L-2004-125

Re: Turkey Point Units 3 and 4
Docket Nos. 50-250 and 50-251
Request for Additional Information -
Triennial Fire Protection Inspection

NRC Request:

Figure 1: Relative location of the emergency switchgear room to auxiliary shutdown panel in the switchgear room.

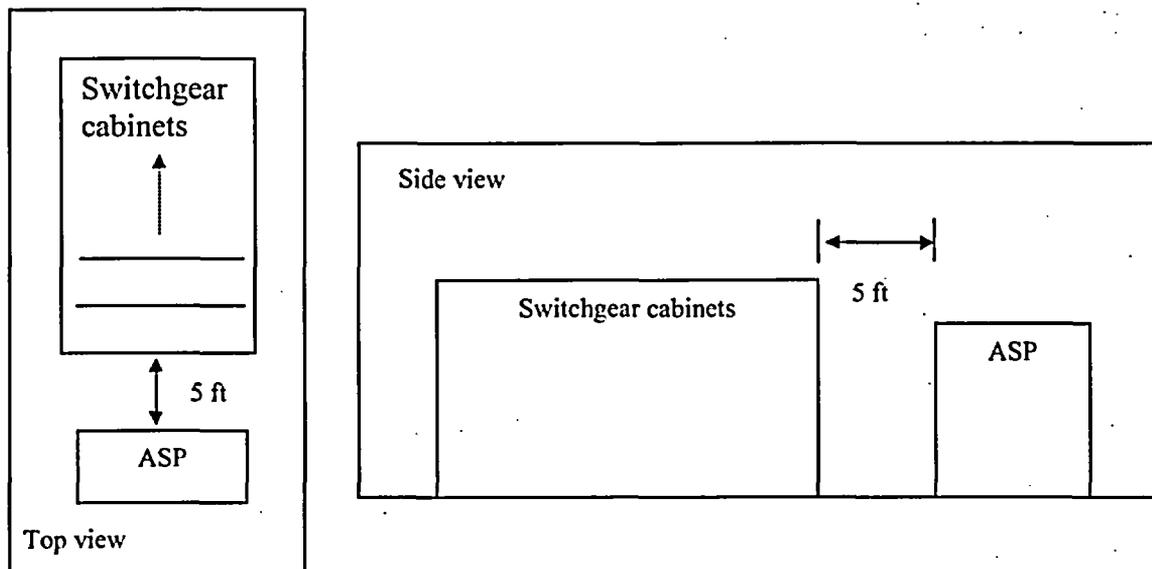
This section describes the thermal insult from a 4160 V switchgear fire to the auxiliary shutdown panel (ASP) located in the same switchgear room. The ASP faces the side-wall of the switchgear cabinet. Figure 1 illustrates the relative location of the ASP to the switchgear cabinet. The switchgear room is 73 ft x 18 ft x 23 ft high.

The flame radiation 5 ft away from a fire in the closest switchgear cubicle to the ASP is 3.8 kW/m². This value is lower than the critical heat flux for unqualified cable considered in the EPRI-NRC/RES fire risk re-quantification project (5 kW/m²). Notice that a 267 kW fire was considered for the analysis since there is only on tray above the closest switchgear cubicle to the ASP. Furthermore, given the location of the fire will likely be in the top section of the cabinet, the ASP may not receive direct radiation from the flames.

A switchgear cabinet fire in the 4B switchgear room will not generate damaging conditions to the ASP. Specifically, two fire generated conditions could potentially damage the ASP. Those conditions are flame radiation, and smoke layer temperature. The fire modeling analysis described in this letter report indicates that no damage is expected.

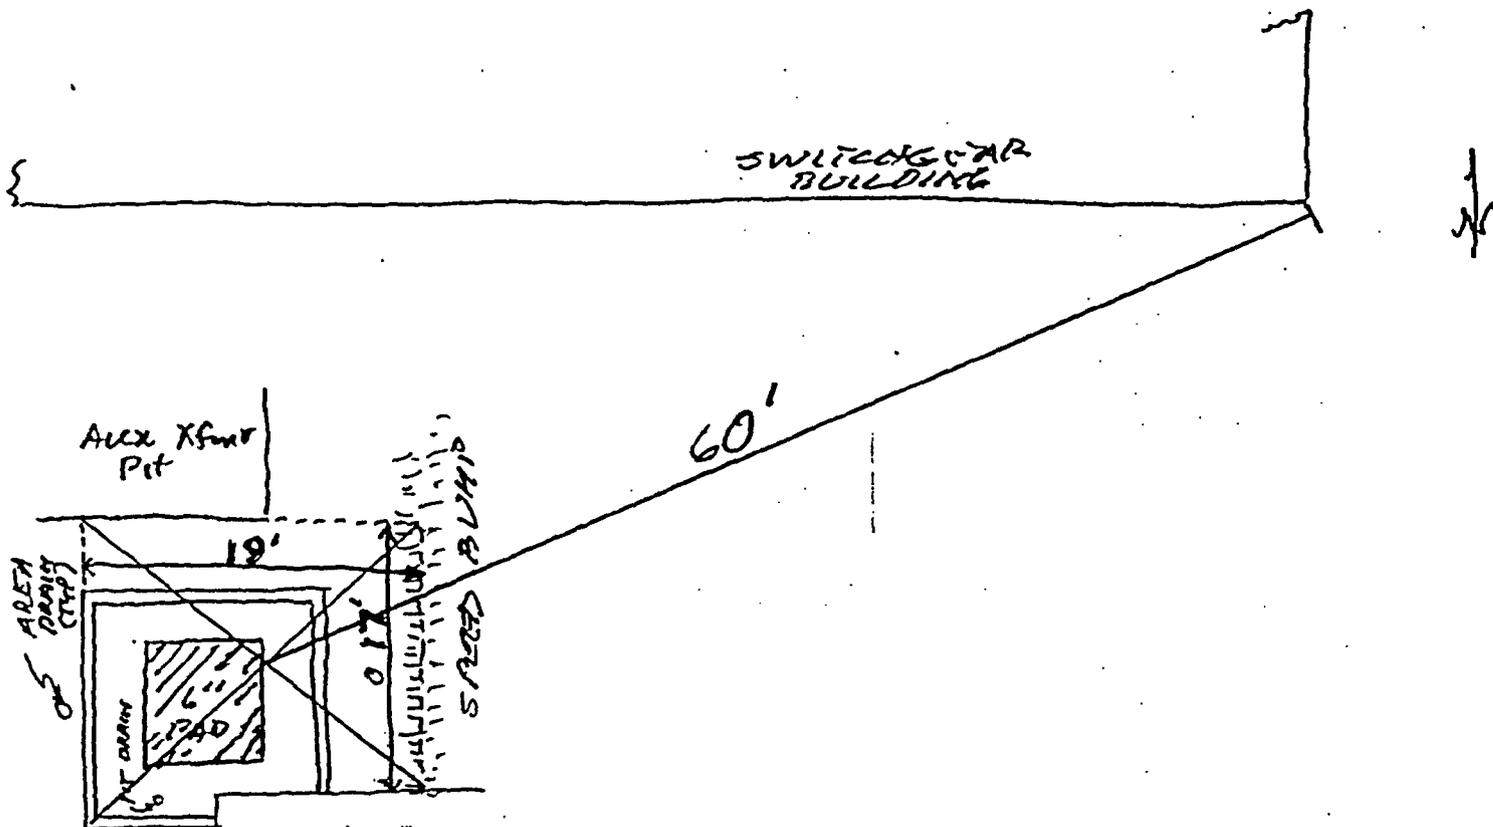
Augmented Response to Question #76

The curb for the Unit 3 Turbine LO Storage Tank is nominal 7". There is no drain but there is a nominal 3.5" weir along the west side which directs overflow into the Unit 4 Startup Transformer pit. The transformer contains 9909 gal. The tank contains 13,875 gal. The transformer pit alone can accommodate 14,313 gal. Therefore, the combined available volume in the pit and curbed area should accommodate a lube oil spill without overflow to other areas. The containment wall encompassing the Unit 4 Turbine LO Storage Tank appears sufficient to contain the 13,875 gal. inventory.

Curbing and equipment pad for each Hydrogen Seal Oil Unit is nominal 6". The FHA reflects an oil inventory volume of 846 gallons. The net containment volume (curbed volume less equipment pad and pipe support volumes) is less than this inventory. There is a drain in the contained area to support containment that drains to the oil/separator at the fossil plant discharge (Drawings 5610-M-75 and 5610-C-13). Also, any overflow would spread on the turbine building floor to nearby area drains to the east and west of the curbed area. Spreading eastward would be limited by the "speed bump". The east drain was recently installed in conjunction with Thermo-Lag upgrades via PCM 97-024. Likewise, the speed bump was installed and ramps 2' on either side of the peak approximately 2.5" above nominal floor level (layout drawings attached). Therefore, most of the spillage beyond the curb would be removed by area drains such that oil spread and depth beyond the curb area would be minimal.

In addition, compliance with NFPA 30 is "in General" (Page 9.6A-32), meaning that PTN mostly complies with the guidance but not absolutely. Appendix 9.6A, page 9.6A-14, references Table 9.6A-12 for a listing of the NFPA codes used at Turkey Point for applicable guidance and NFPA 30 is not on that list. The current Technical Specifications, those in effect prior to converting the Technical Specifications into the UFSAR, and the SER for the License Amendment that authorized that shift made no specific mention of compliance with NFPA 30. No specific commitment to NFPA 30 was found than on page 9.6A-32. Note that CR 04-0369 was initiated to address PTN compliance requirements to NFPA.

A Night Order was issued for increased awareness, by Operators, of unusual heat sources in the areas of the hydrogen seal oil units. Also, a preliminary risk-significance assessment was performed assuming spillage from the hydrogen seal oil units is not contained by the curbs but overflows to the turbine building floor. An illustration of assumed oil pool spreading limits and relative distance to a vulnerable target (Train A cable) are illustrated. The NUREG-1805 spreadsheet for this condition is also provided and indicates screens below cable qualification limits prior to reaching the vulnerable cable. This assessment will be finalized via CR 04-0477.
